FORD E4OD "UPDATE HANDBOOK"

*Updated
April, 2004*

VALVE BODY, SPACER PLATE, SPACER PLATE GASKETS, CHECKBALL LOCATIONS, AND CASE CHANGES, FOR THE 1996 MODEL YEAR

Figure 1
 AUTOMATIC TRANSMISSION SERVICE GROUP

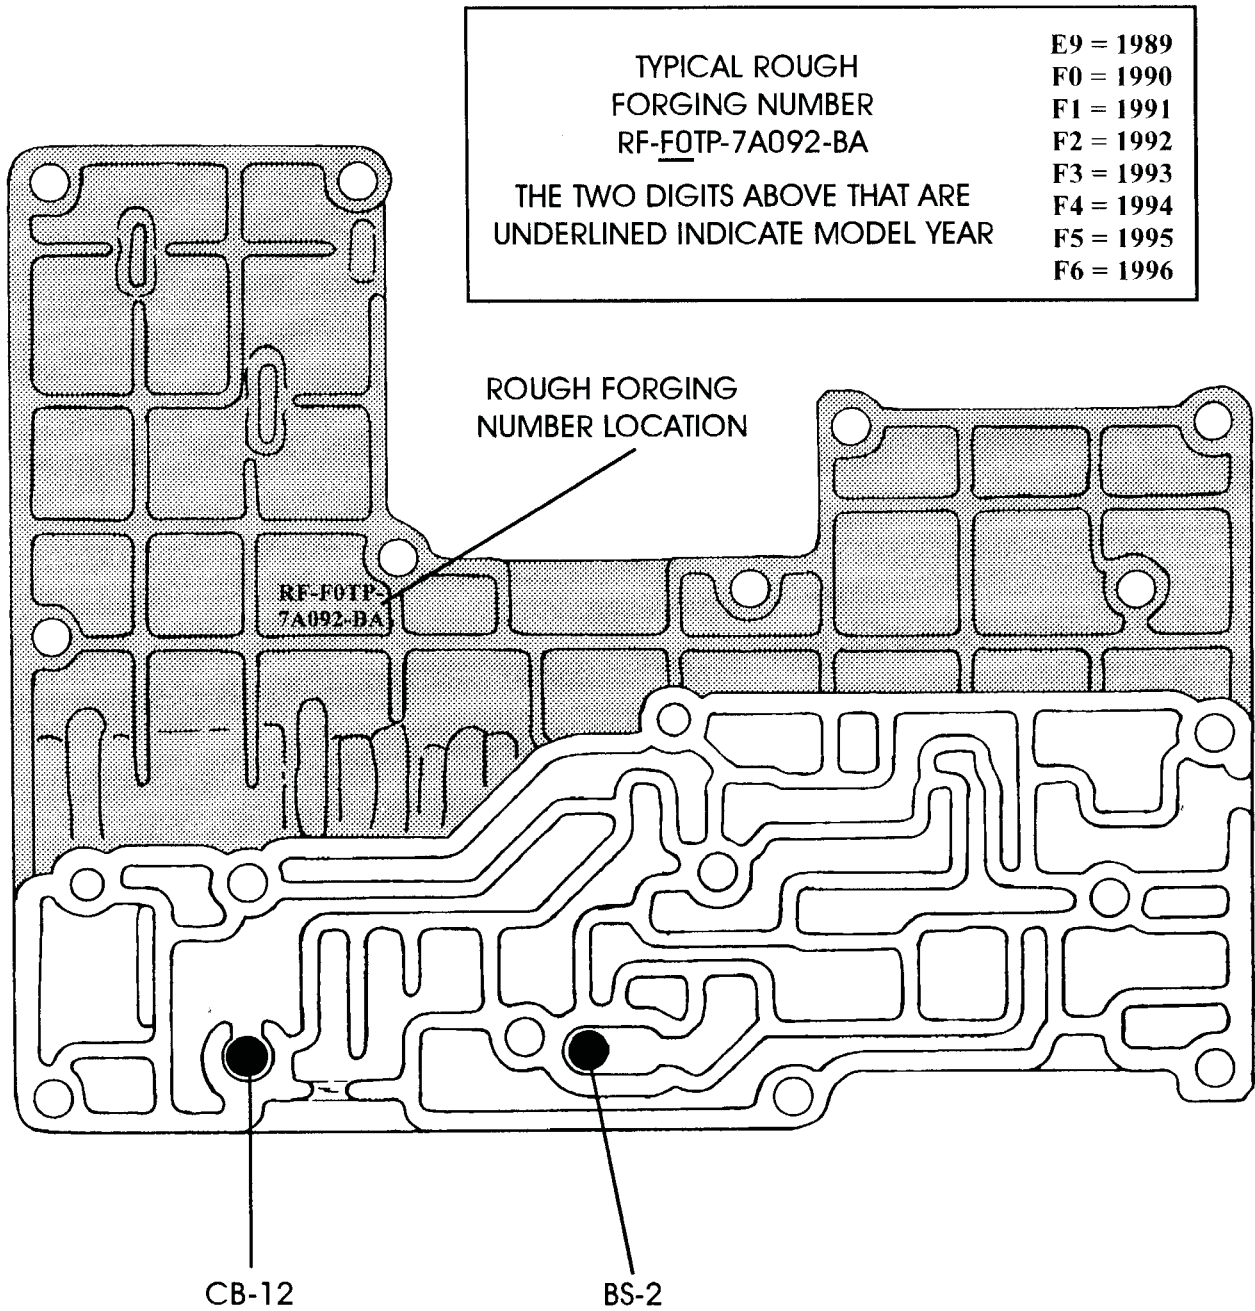
- (1) **VALVE BODY CHECKBALL LOCATIONS** - Have remained the same for 1989 thru 1995 model years, with **TWO** 5/16" rubber checkballs, and their locations are shown in Figure 1. Beginning in the 1996 model year there are **FIVE** checkballs in the main valve body and their locations are shown in Figure 2. Notice that there are two 5/16" rubber balls and three 1/4" rubber balls. The 1/4" rubber balls are green in color (See Figure 2).

Figure 3
 AUTOMATIC TRANSMISSION SERVICE GROUP

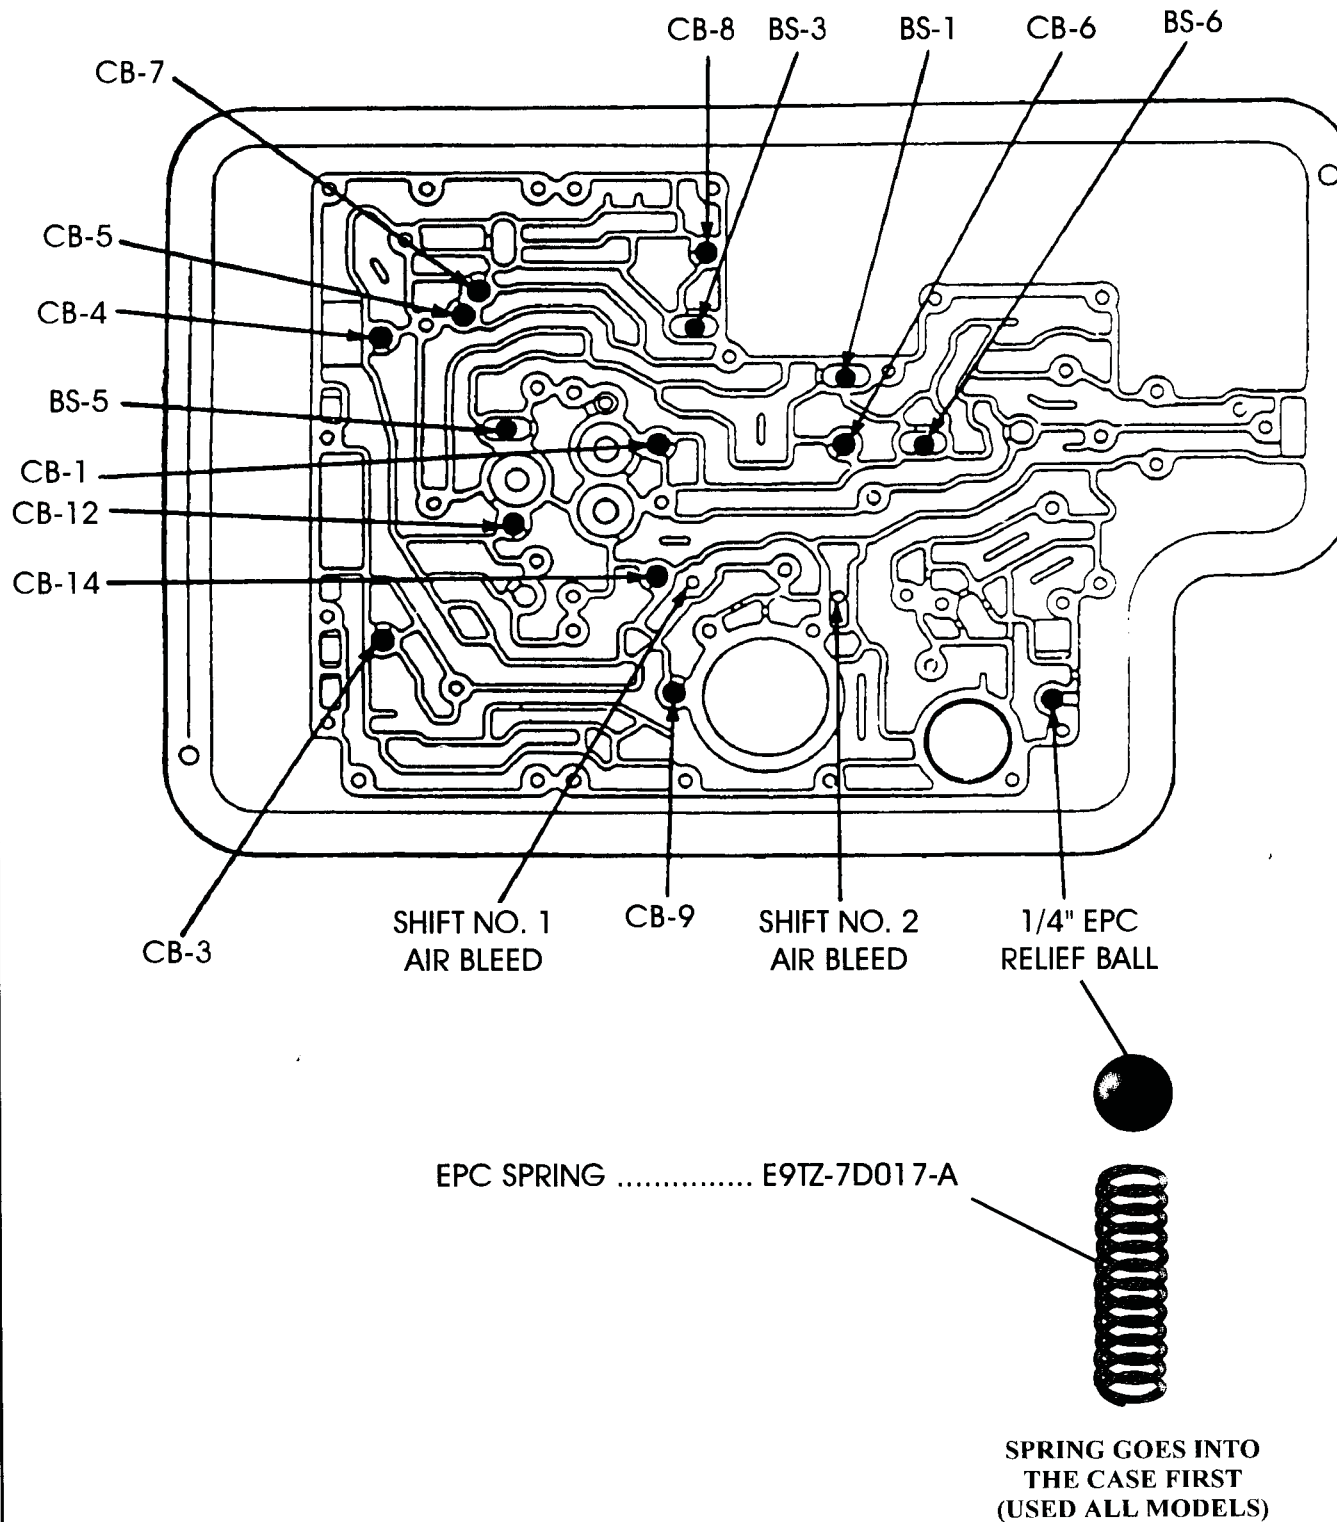
Early 1989 Models - Requires **Fourteen** 5/16" checkballs in the case, in the locations shown in Figure 3, and uses a 1/4" steel ball for the EPC blow-off, and location shown in Figure 3.

Figure 4

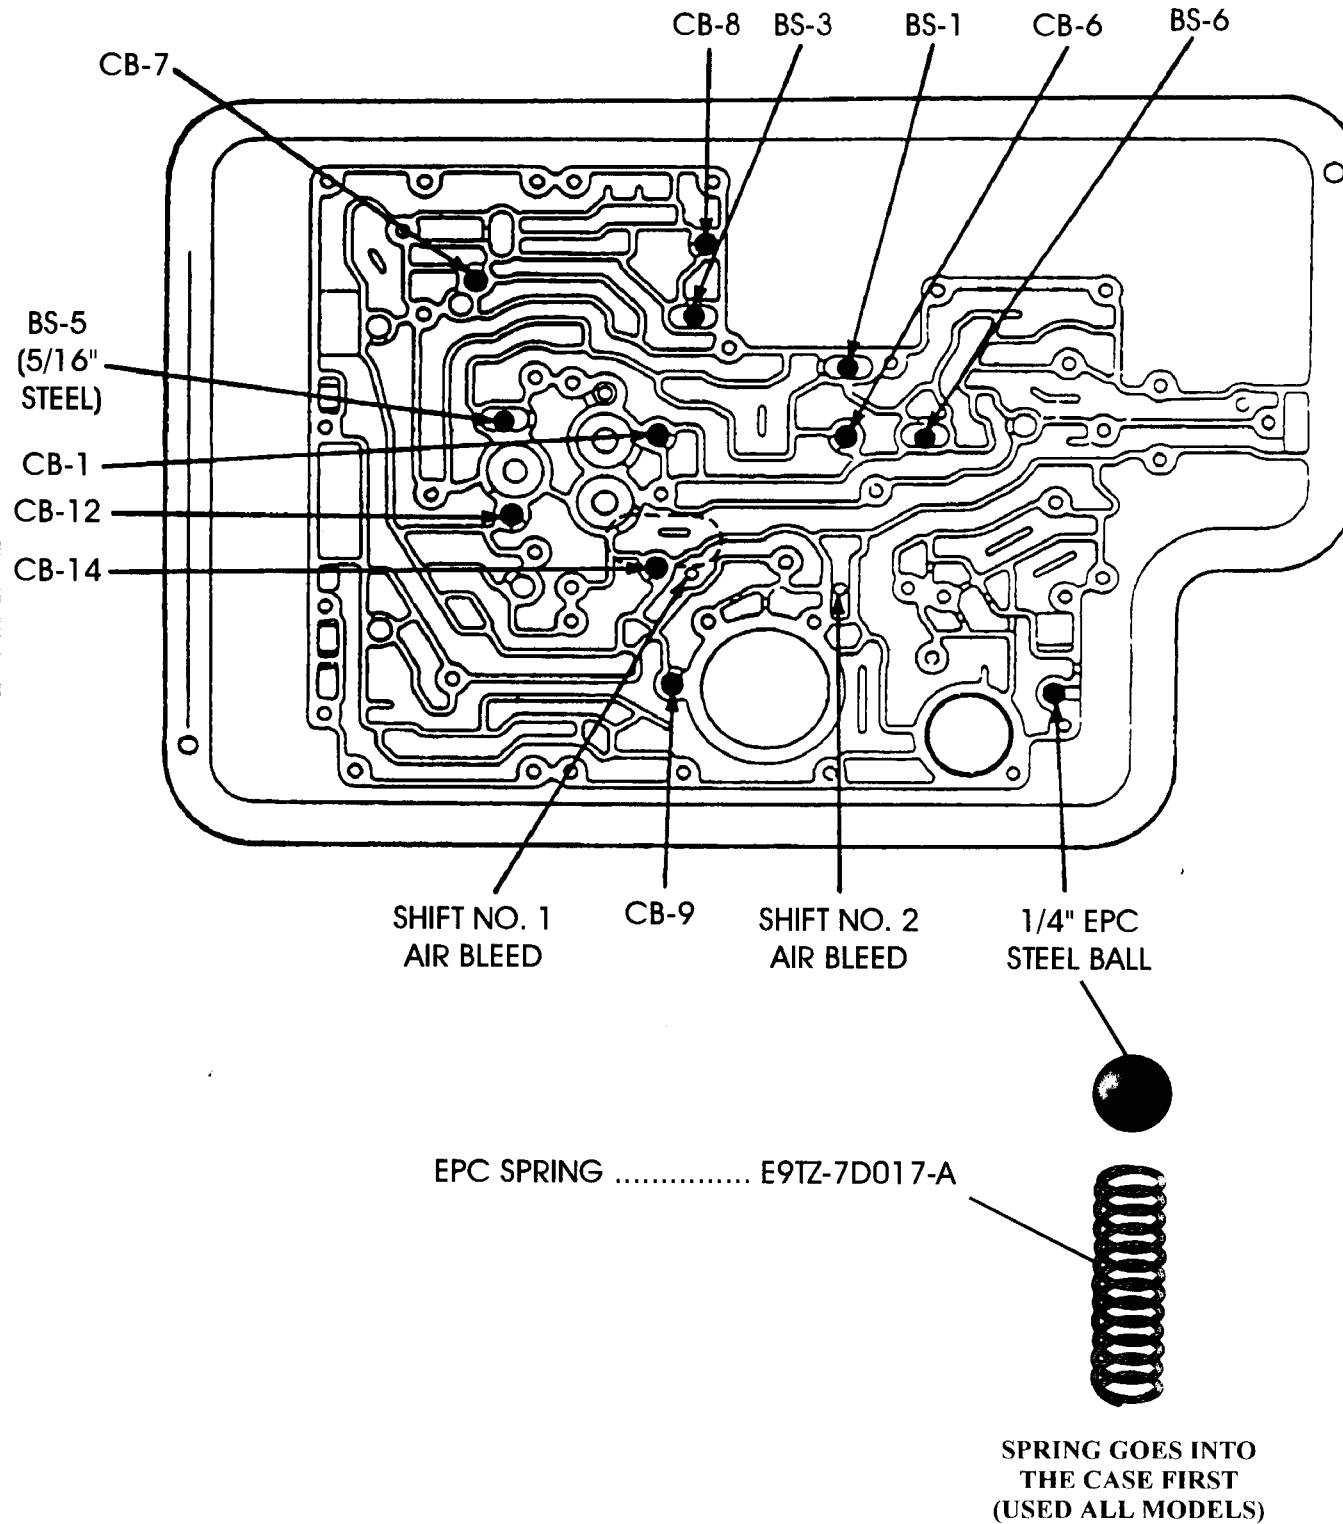
Late 1989 Models - Requires **Ten** 5/16" rubber checkballs, and **One** 5/16" diameter steel checkball, for a total of **Eleven**, in the locations shown in Figure 4, and uses a 1/4" steel ball for the EPC blow-off, and the location is shown in Figure 4.

Figure 5
 AUTOMATIC TRANSMISSION SERVICE GROUP

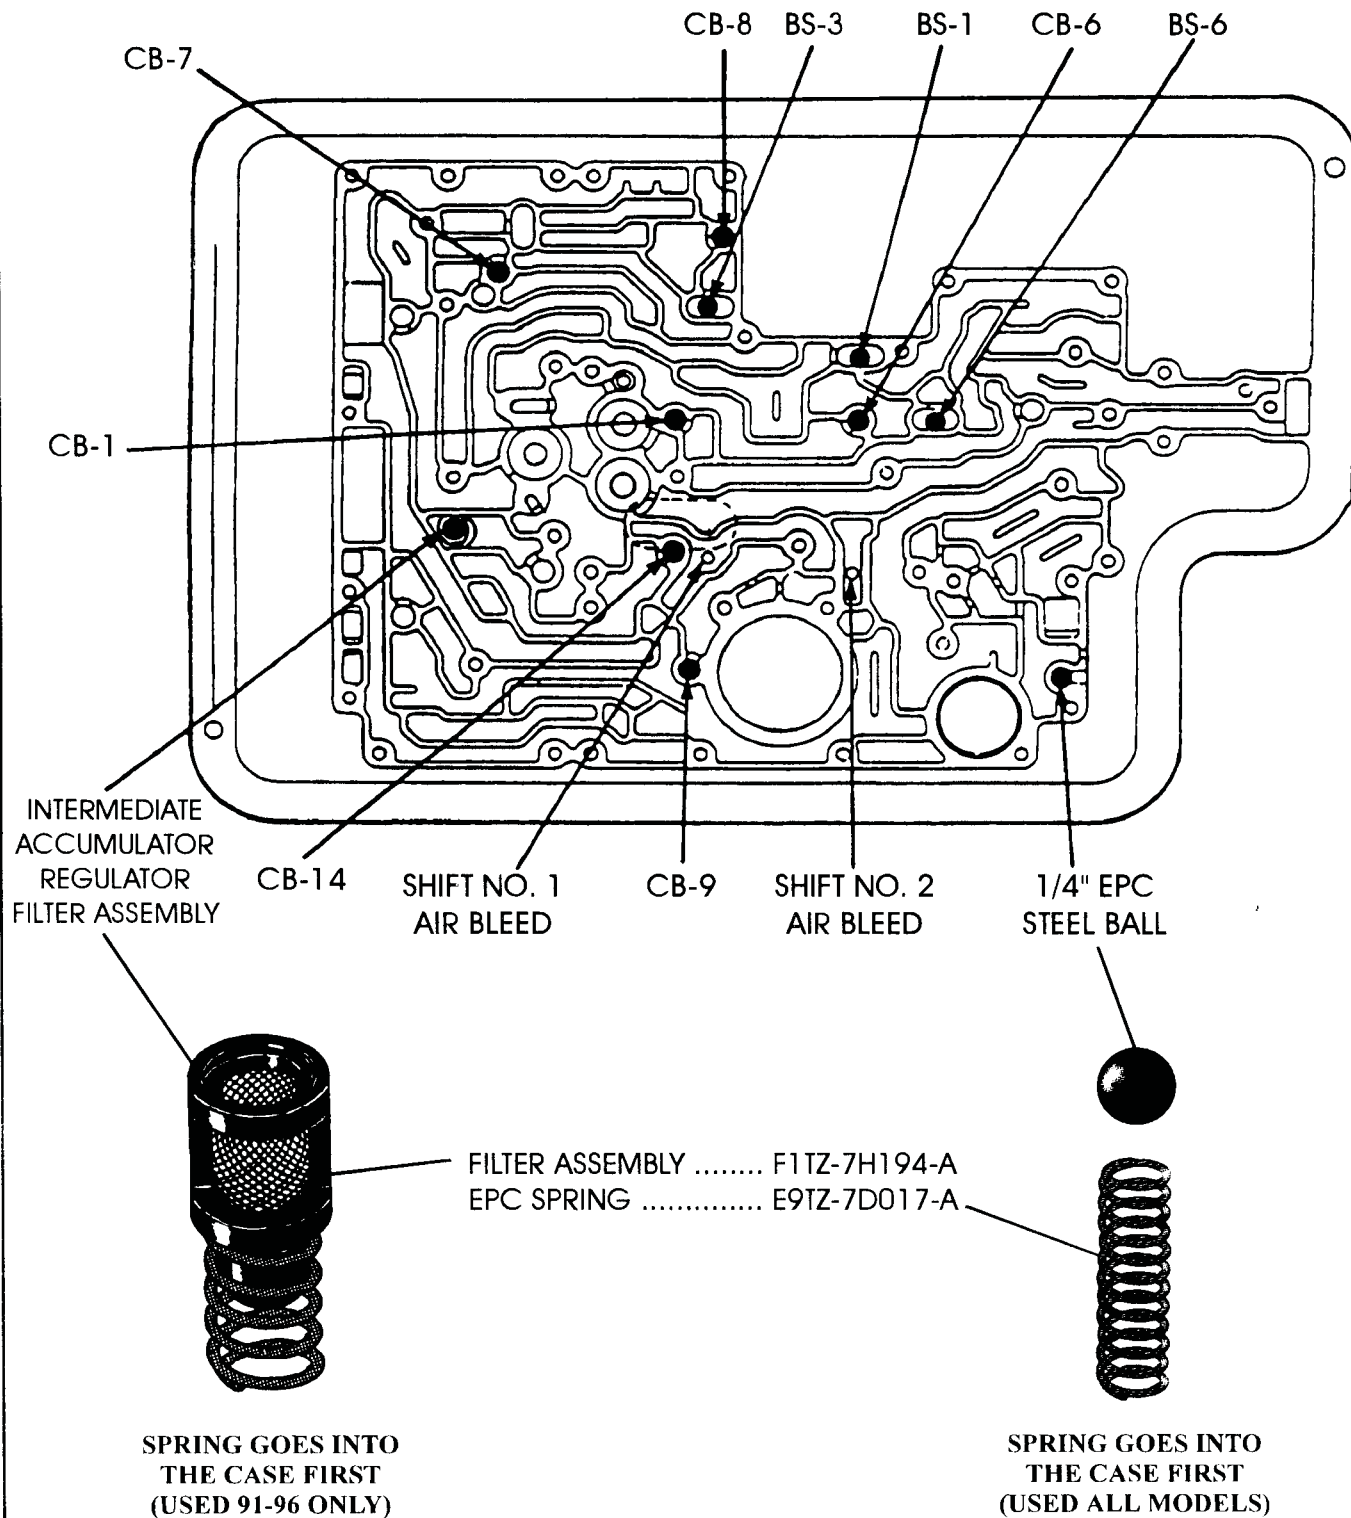
All 1990-1995 Models - Requires **Nine** 5/16" rubber checkballs in the case, in the locations shown in Figure 5, and uses a 1/4" steel ball for the EPC blow-off, and the location is shown in Figure 5. Beginning in 1991 there is an added Intermediate Accumulator Regulator Filter Assembly, and the location in the case is shown in Figure 5.

Figure 6

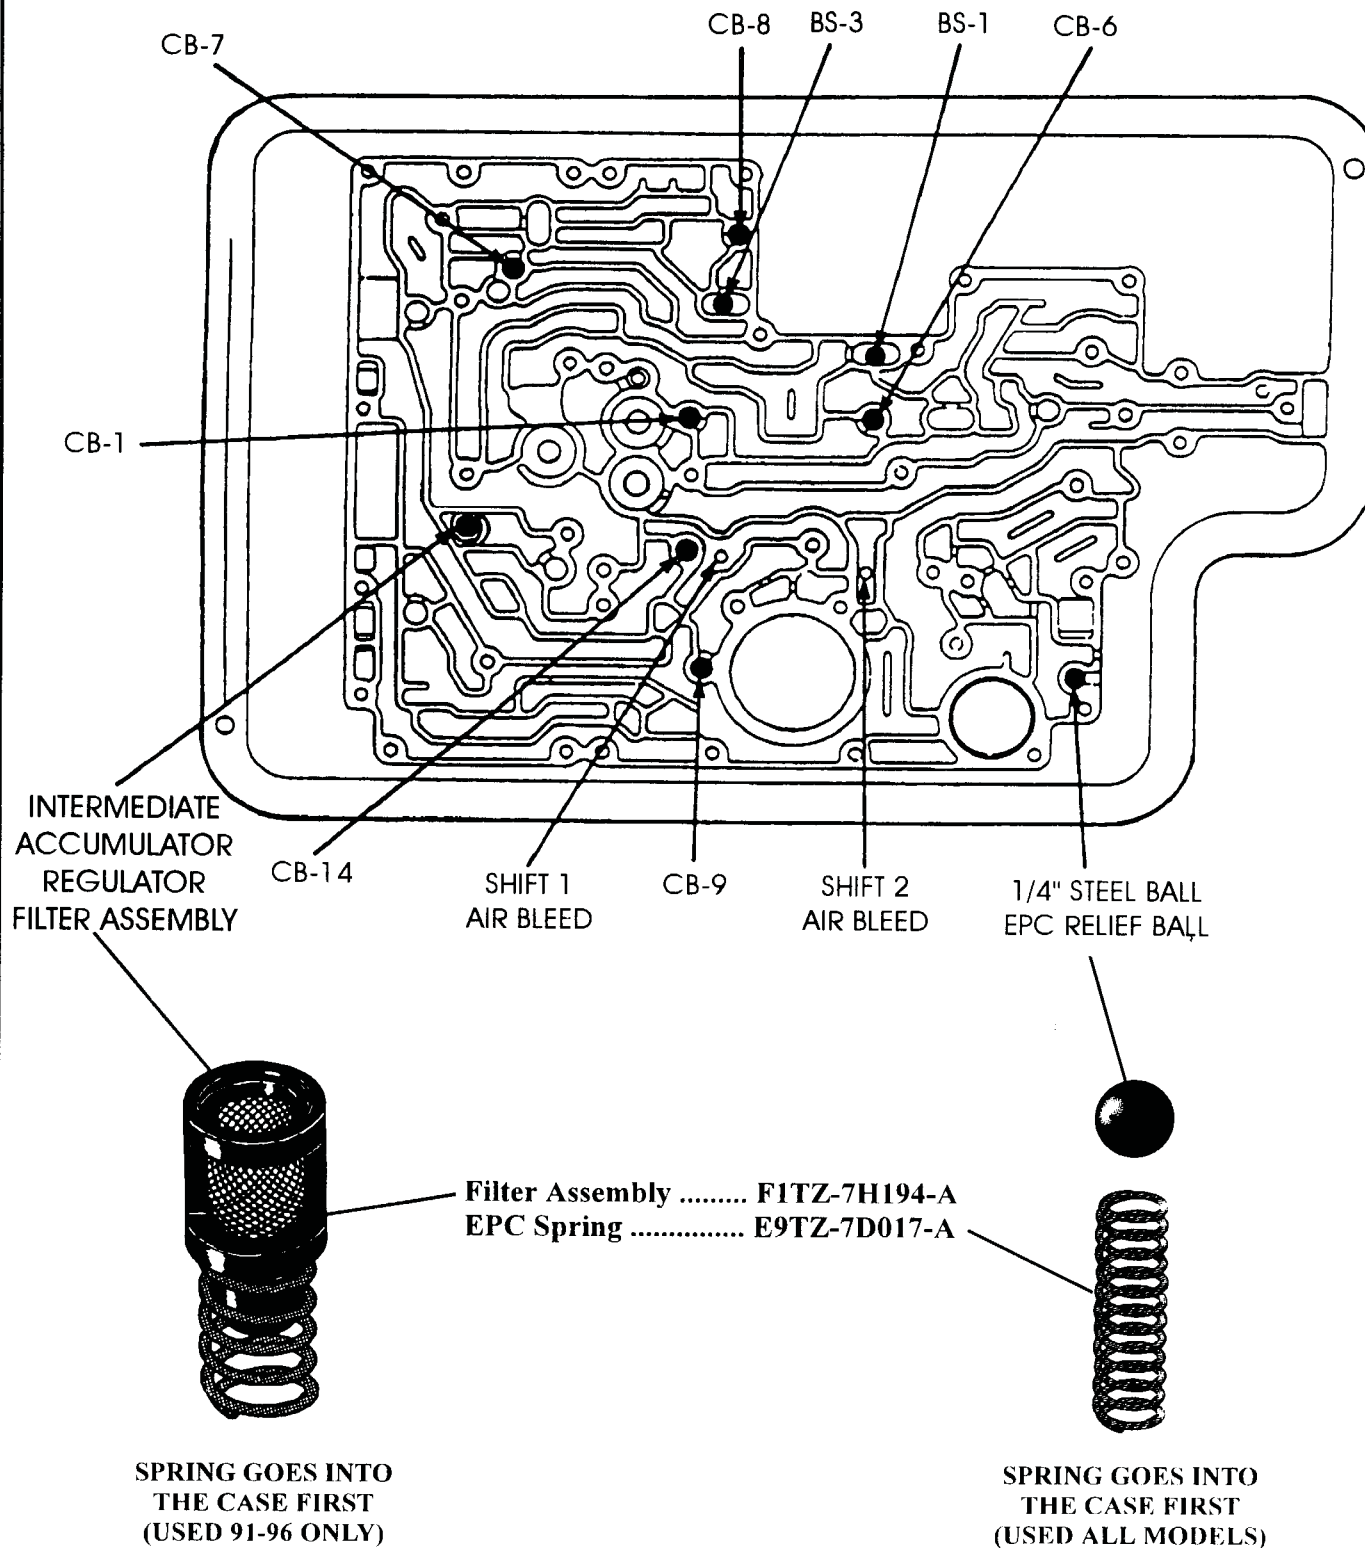
All 1996-UP Models - Requires **Eight** 5/16" rubber checkballs in the case, in the locations shown in Figure 6, and uses a 1/4" steel ball for the EPC blow-off, and the location is shown in Figure 6.
